Wisconsin Department of Transportation

Proposal #05: 2040-11-70, WISC 2017 452

108th Street (Hales Corners)

This is Addendum No. 01, which provides for the following:

Addendum No. 01 ID 2040-11-70 Revised Plan Sheet 86 September 1, 2017

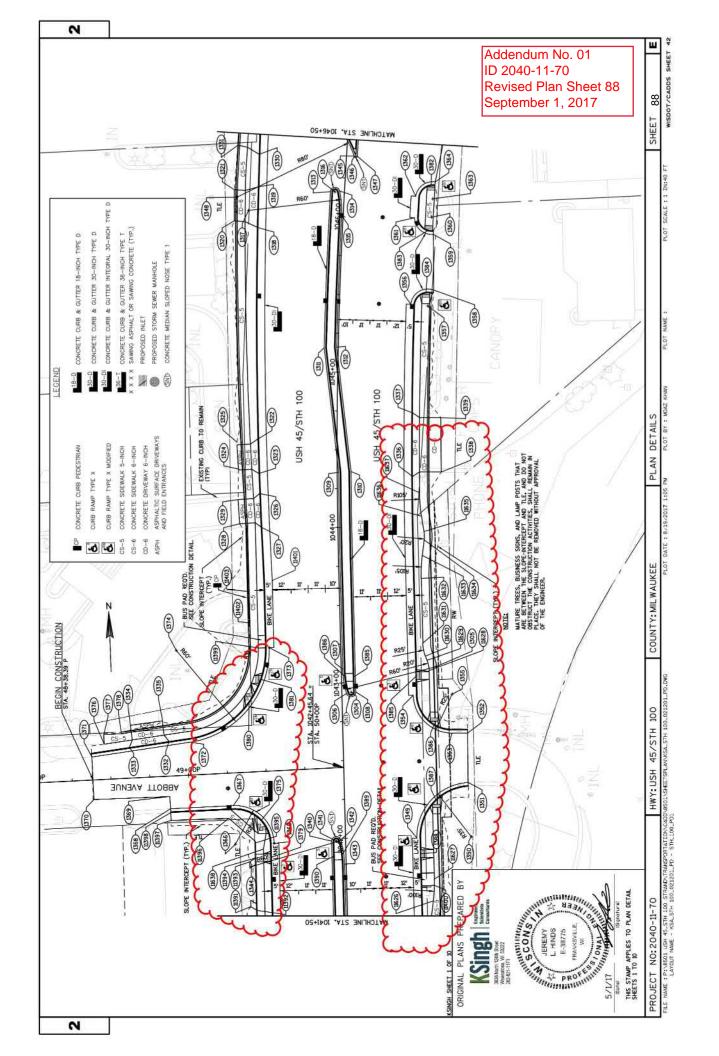
Revised Plan Sheets
Plan Sheet	Plan Sheet Title (brief description of changes to sheet)
17	Typical Section, Terrace dimension was revised.
83 - 89	Plan Details, sidewalk layout on east side of STH 100 from Grange Avenue to Sta. 1044+21
	RT was revised and additional points were added on data table.
131 – 134	Curb Ramp Detail - Abbott Avenue, curb ramp layout and data point information were revised.
149 – 152	Paving Grades, sidewalk layout on east side of STH 100 from Grange Avenue to Sta. 1044+21 RT was revised.
170 – 171	Erosion Control, EMAT Urban Class I Type A was added in missing areas and revised from Grange Avenue to Station 1044+21 RT.
176 – 178	Erosion Control, EMAT Urban Class I Type A was added in missing areas and revised from Grange Avenue to Station 1044+21 RT.
180 – 182	Erosion Control, EMAT Urban Class I Type A was added in missing areas and revised from Grange Avenue to Station 1044+21 RT.

Addendum No. 01 ID 2040-11-70	۲
										Revised Plan Sheet 151 September 1, 2017	757
	12051F	SS SS A	20.782						-	\sim	CUEET
794,89	25.35	795.13 04	AT2	734-93 W	THO SE	DIA.	M	794.89	4	3

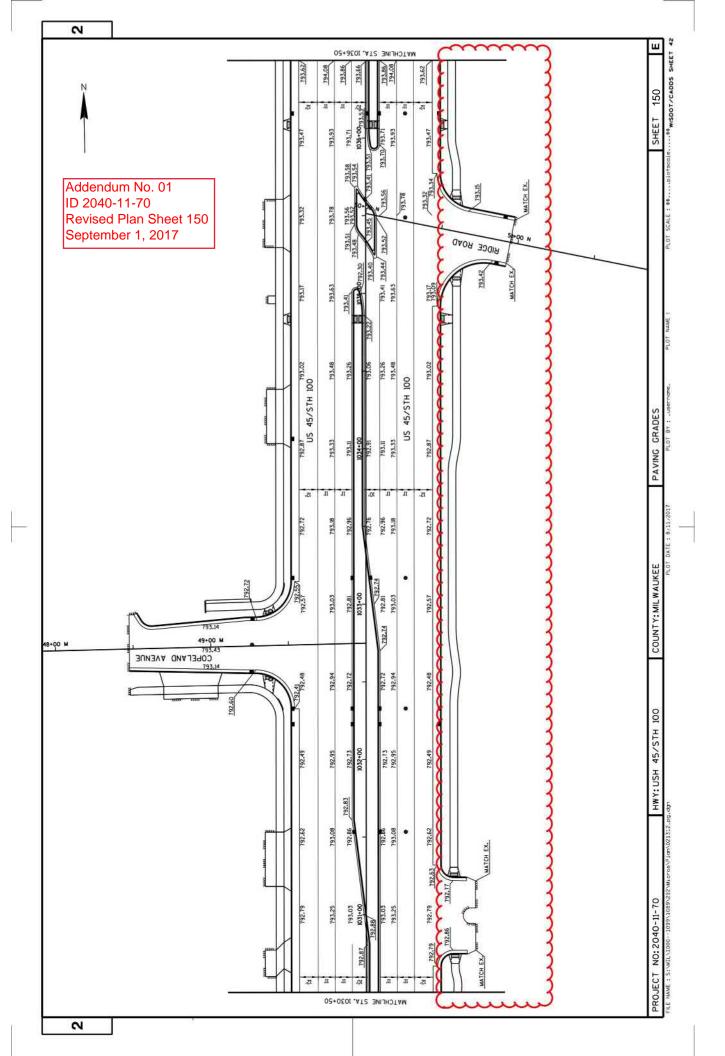
The following $8\frac{1}{2}$ x 11-inch sheets are attached and made part of the plans for this proposal: Revised: 17, 83 - 89, 131 - 134, 149 - 152, 170, 171, 176 - 178, 180 - 182, 184, 200 - 203, 232 - 235, 291, 293 - 296, 301, 322 - 325, 327, 328, 387 - 389, 400 - 405, 411 - 444, 511 - 514, 542, 545, 546, 559 - 562, 580, 602 - 605, 619, 633, 667, 687, 689, 706, 707, 725, 749 - 751, 753 - 756, 762, 763, 771, 772, 793, 795, 1159 - 1162, 1166 - 1169, 1171, 1172, and 1174 - 1178.
